OCEAN COUNTY HEALTH DEPARTMENT

RE: Septic Design Application
OCHD File 058274/058275
Block 1004 (130.02) Lot 7 (3)
Jackson, NJ 08527

Based upon information submitted on 8/12/2022 regarding the above mentioned proposed RESIDENCE, this agency hereby **approves** the septic plan as submitted. This system is not to include the other structures on this property. Please note this office needs the following prior to issuance of a certificate of compliance:

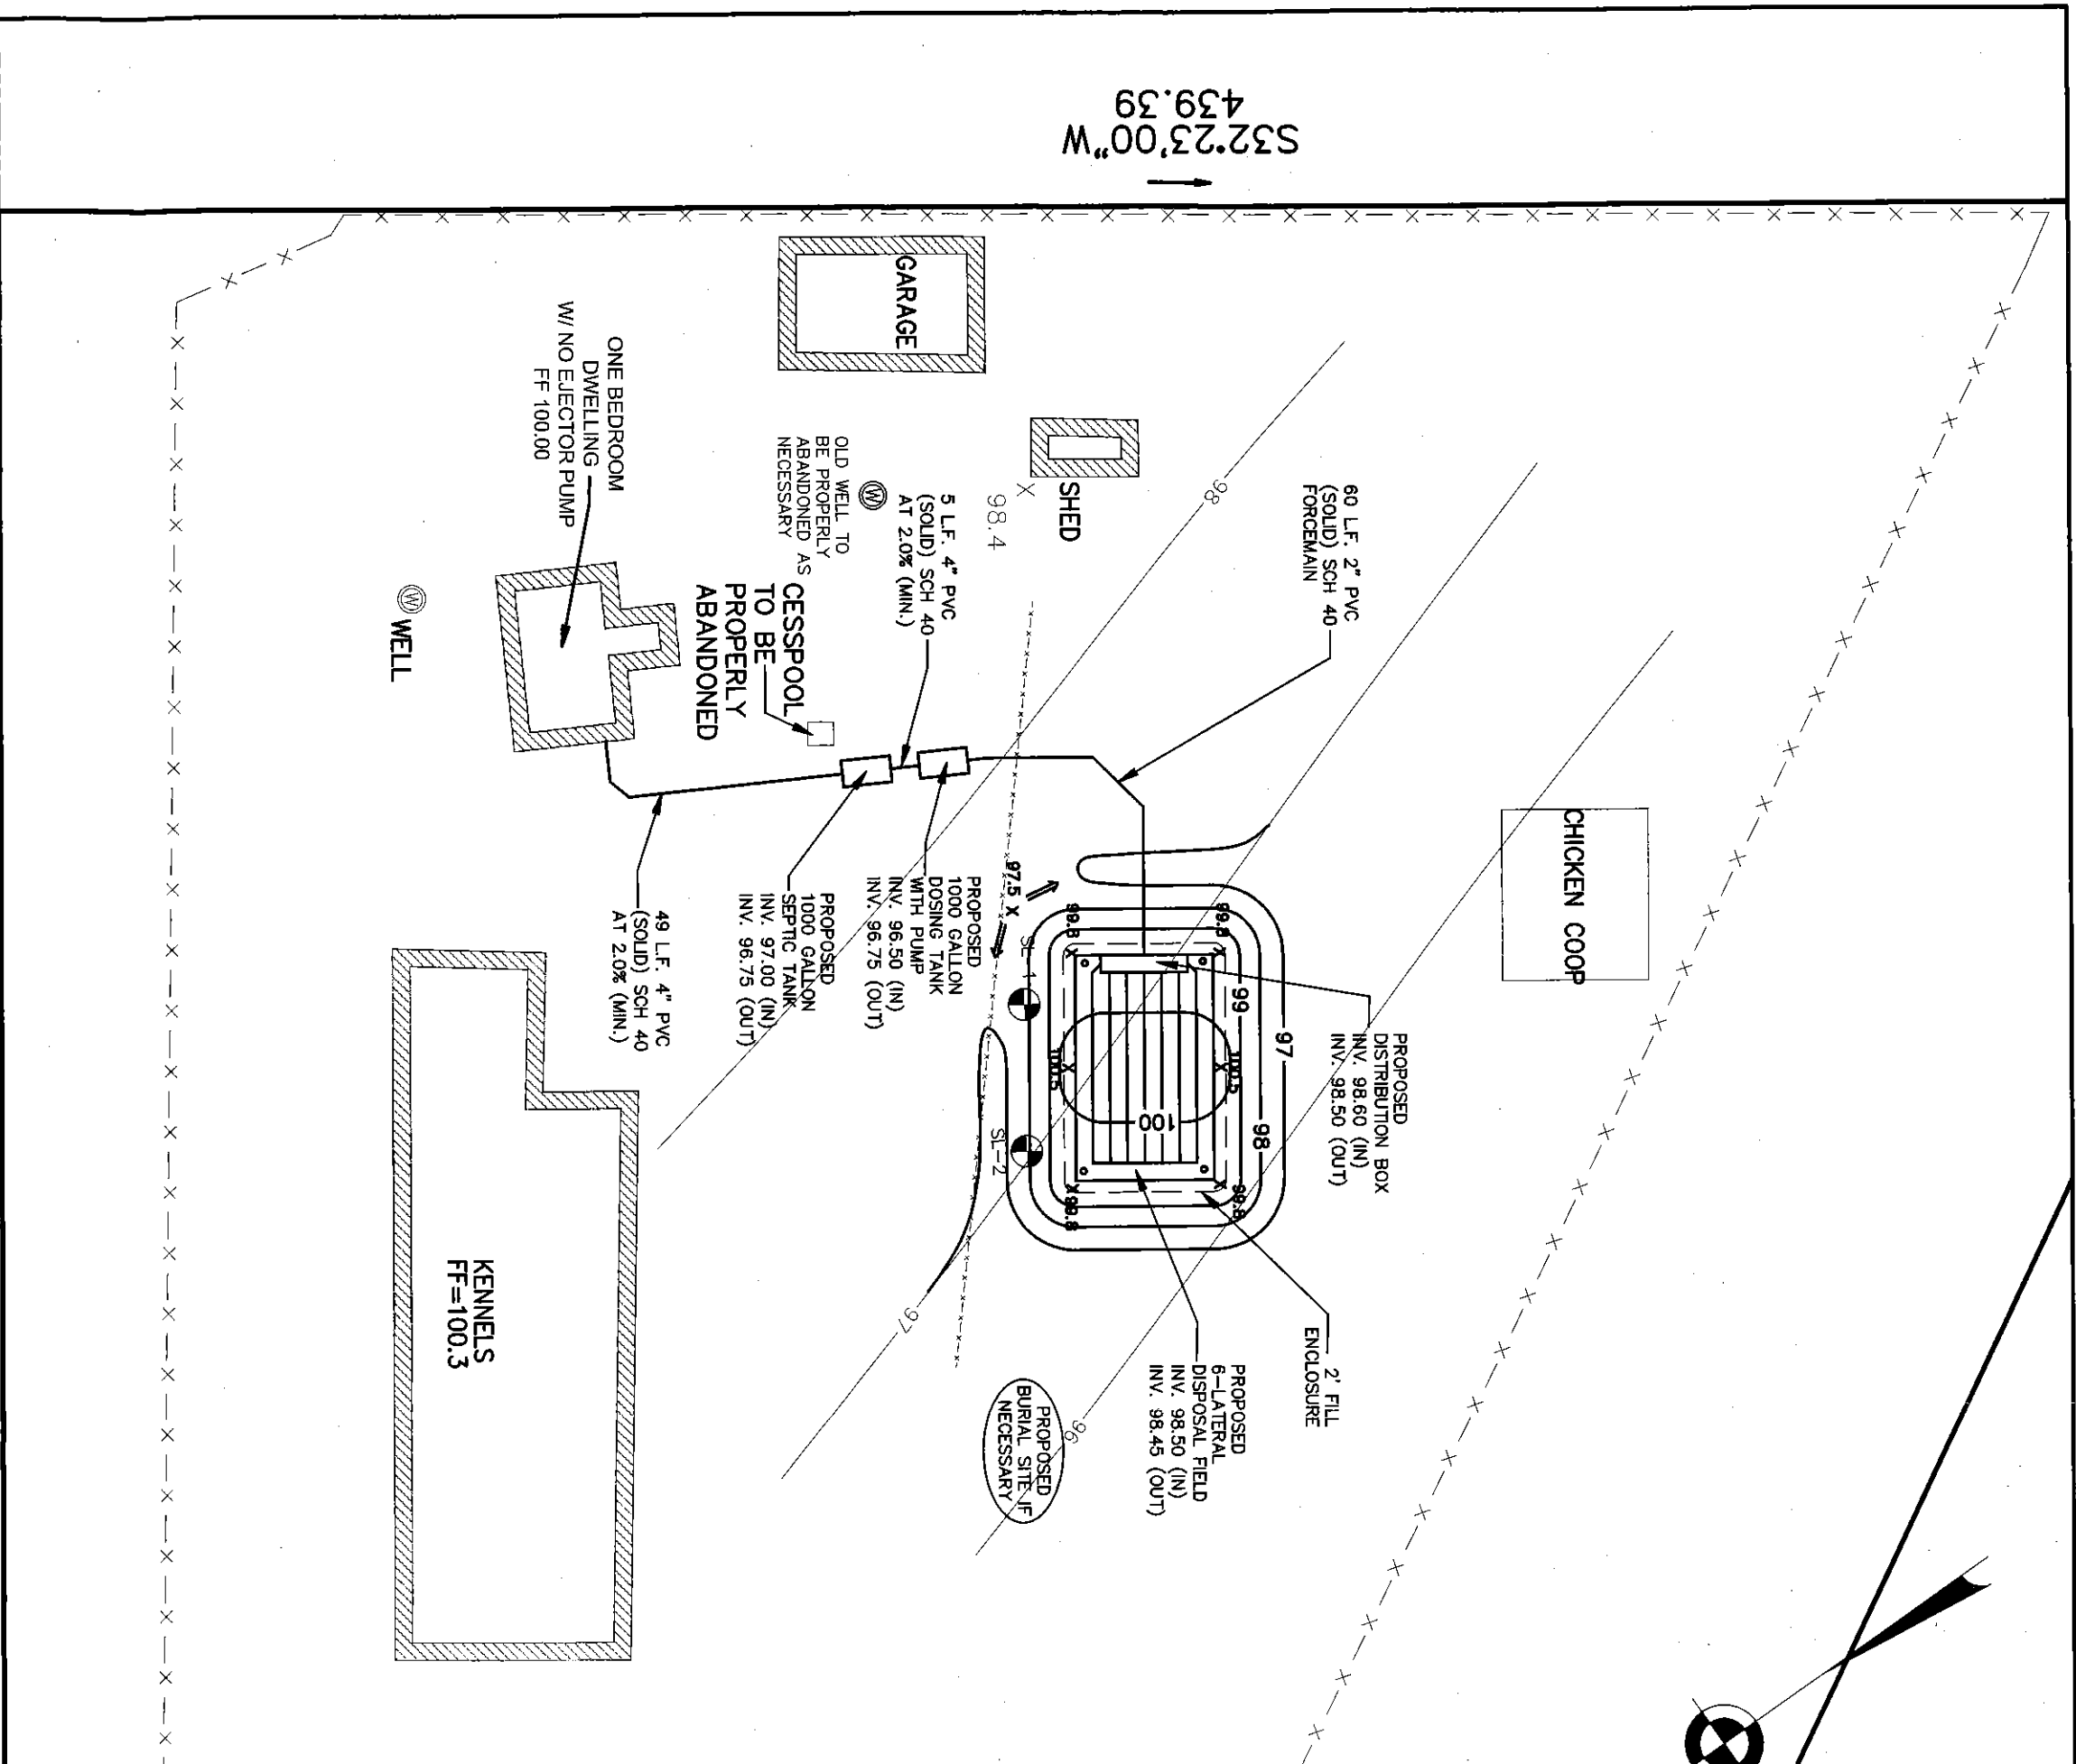
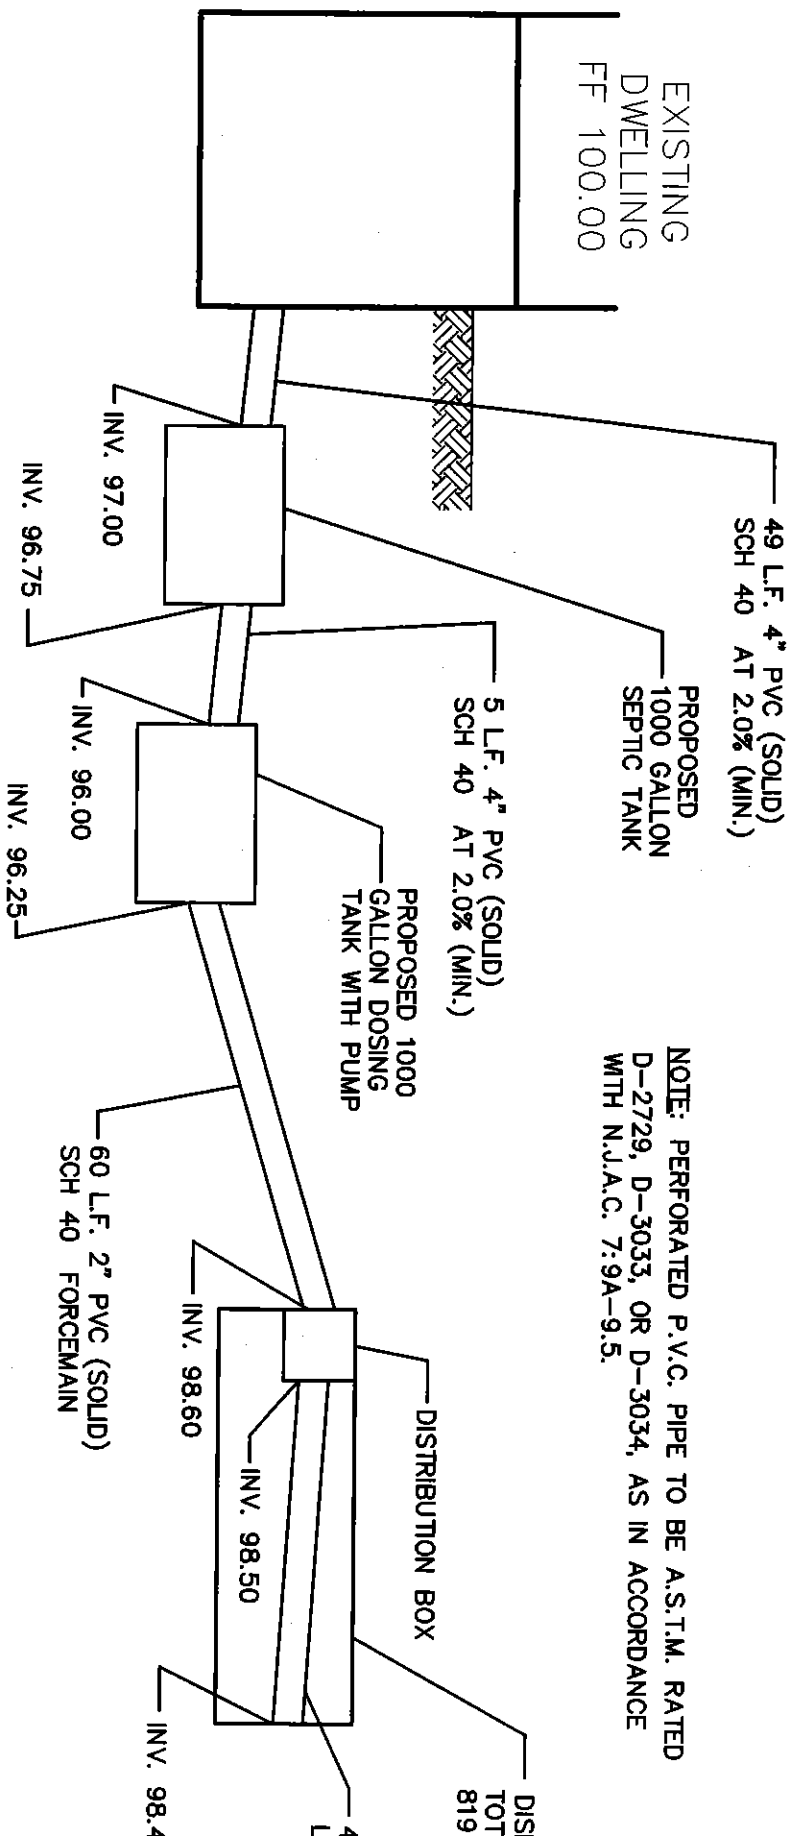
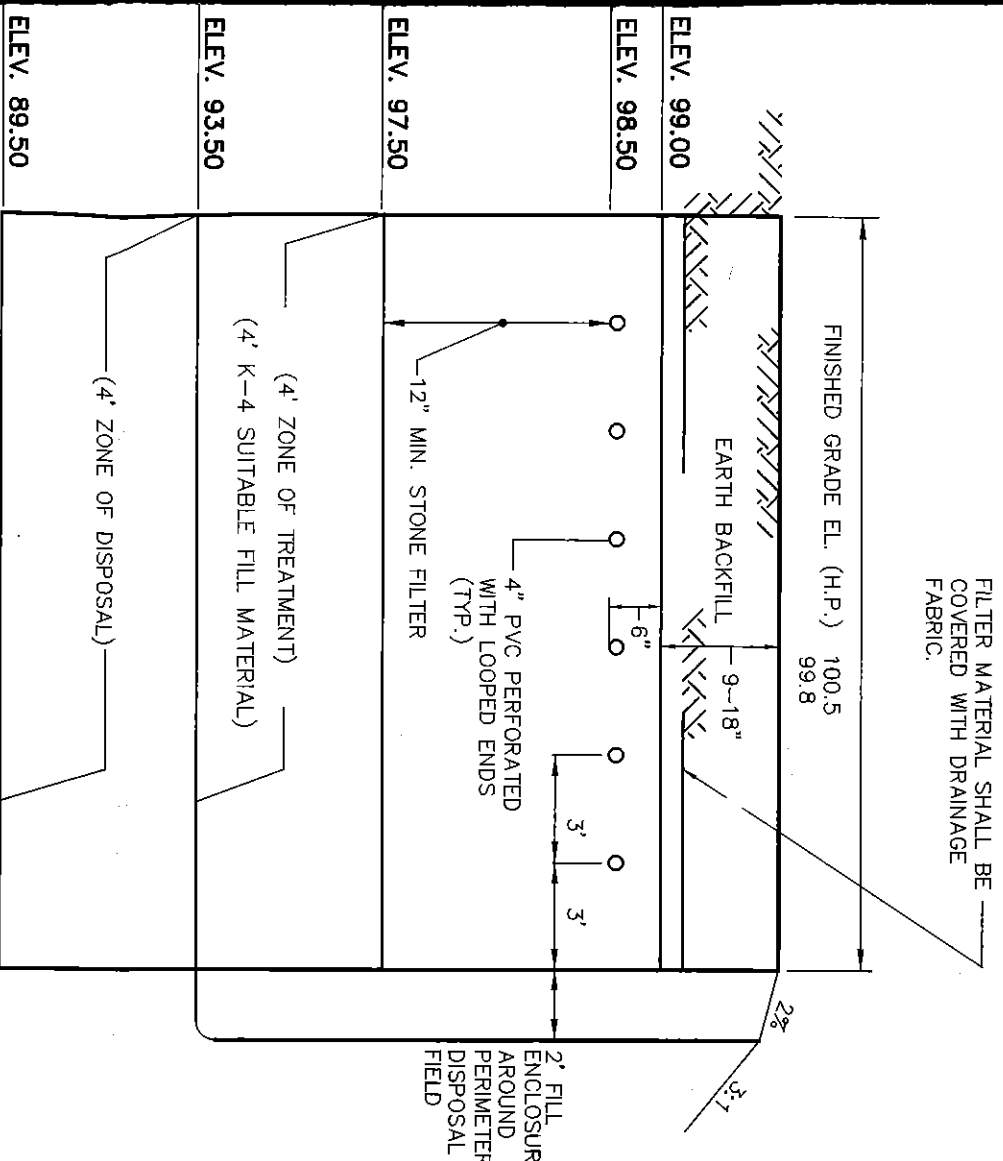
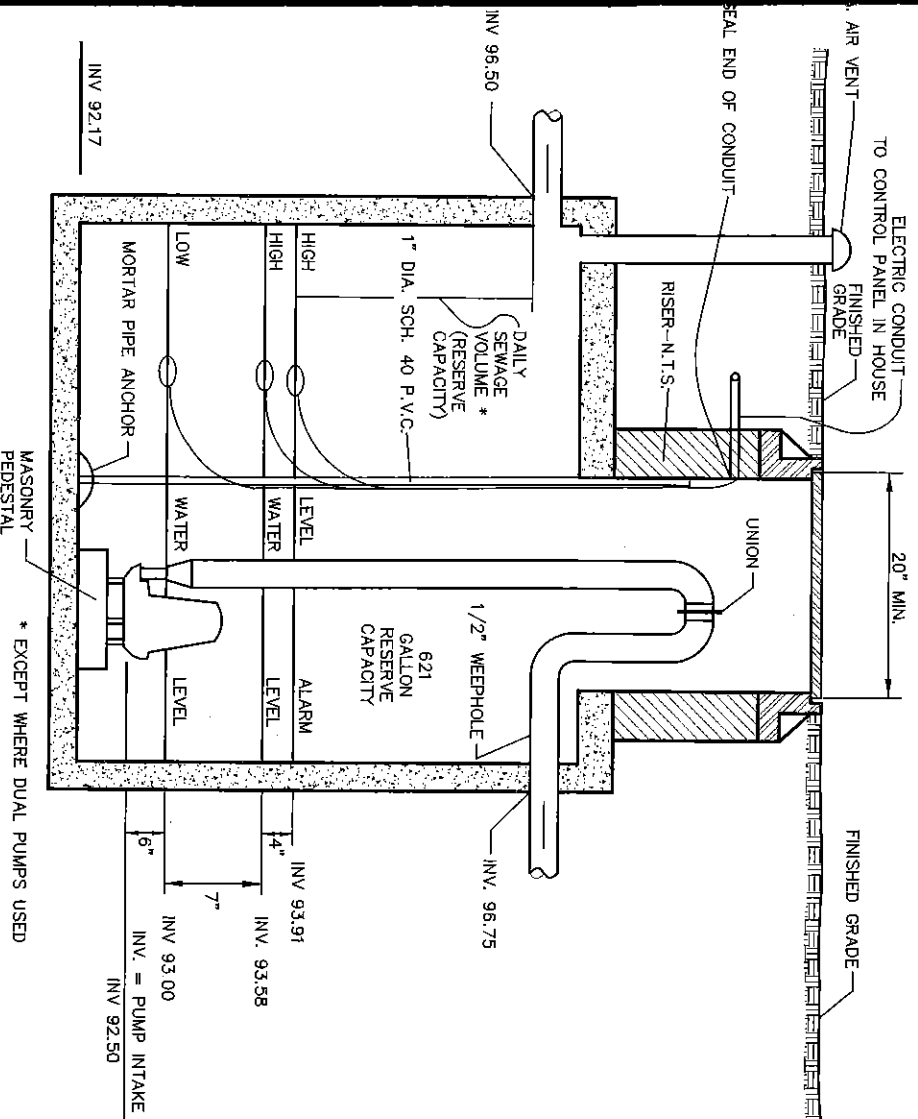
- A well abandonment report from a licensed well driller for the well to be decommissioned on site, as depicted on the site plan.
- Septic plan design sheet indicating all distances regarding the septic system installed.

This sheet needs to be submitted w/ distances prior to issuance of a cert. of compliance by this office
